Quad Cities Station Units 1 and 2

Proposed Changes to DPR-29 and

DPR-30 Technical Specifications

Revised Pages: V (List of Figures)

Figure 6.1-1
Corporate and
Station Organization

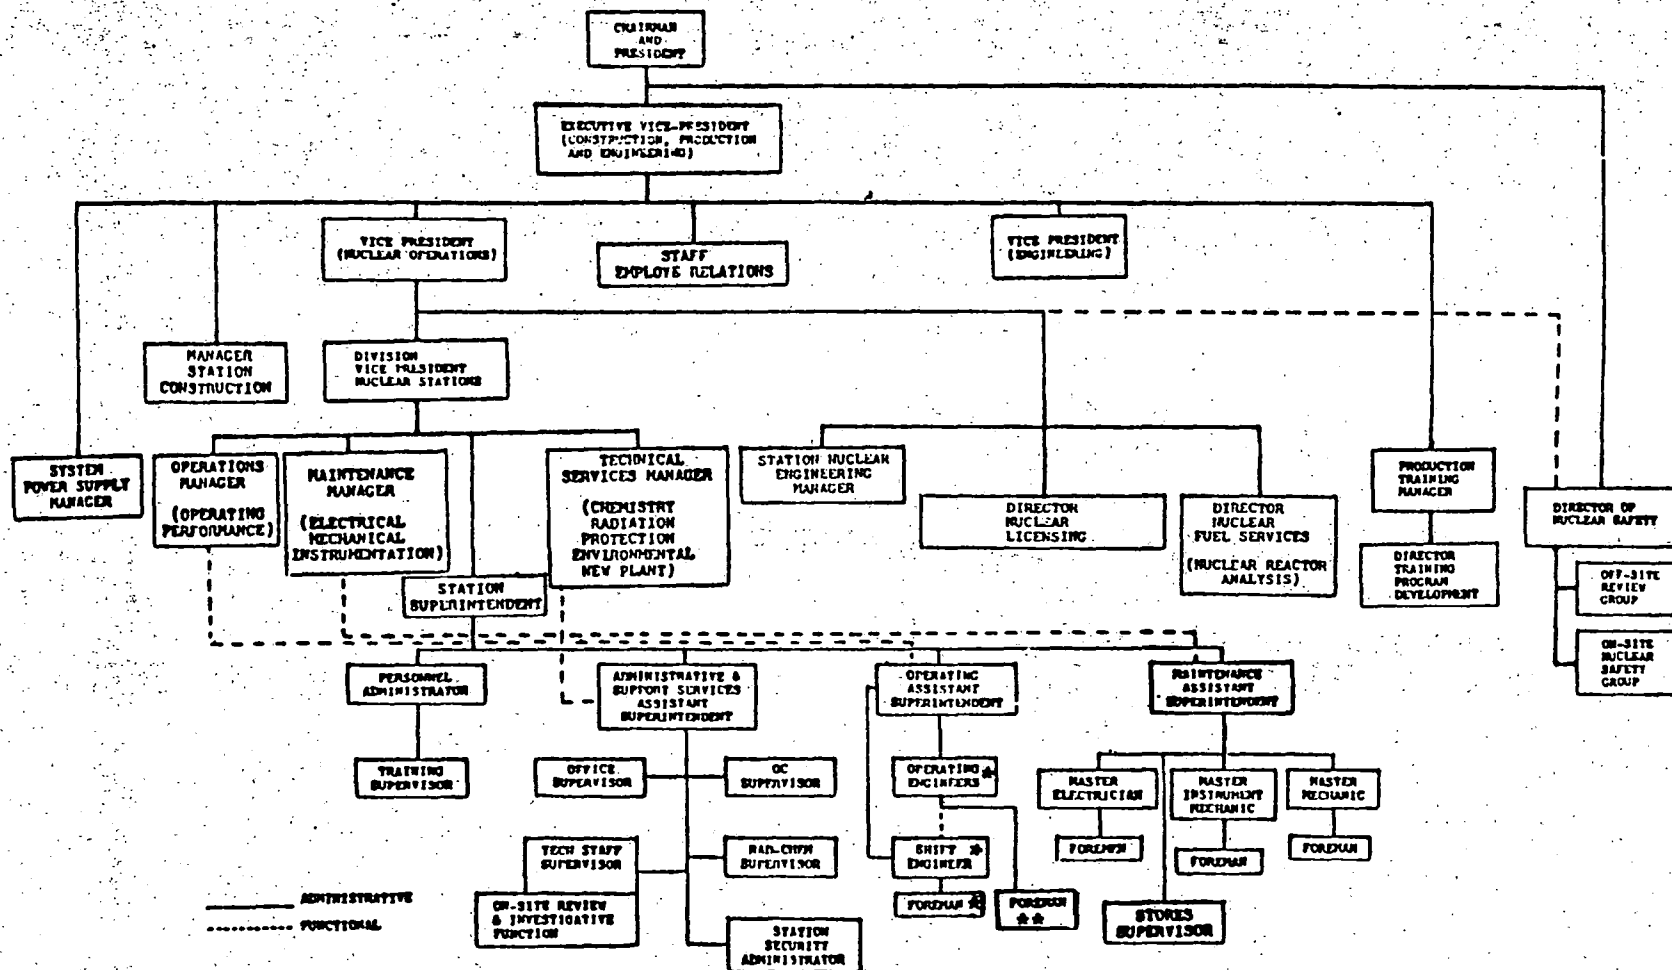
- B. The organization chart of the corporate management which relates to the operation of this station and the normal functional organization chart for operation of the station is shown in Figure 6.1-1.

- * - Senior Operator's License
 - ** - Fuel Handling Foreman has limited Senior Operator's license required only during Fuel Handling
- NOTES - The Maintenance Assistant Superintendent is responsible for implementing the Fire Protection Program
- One Assistant Superintendent or the Station Superintendent has a Senior Operator's license.
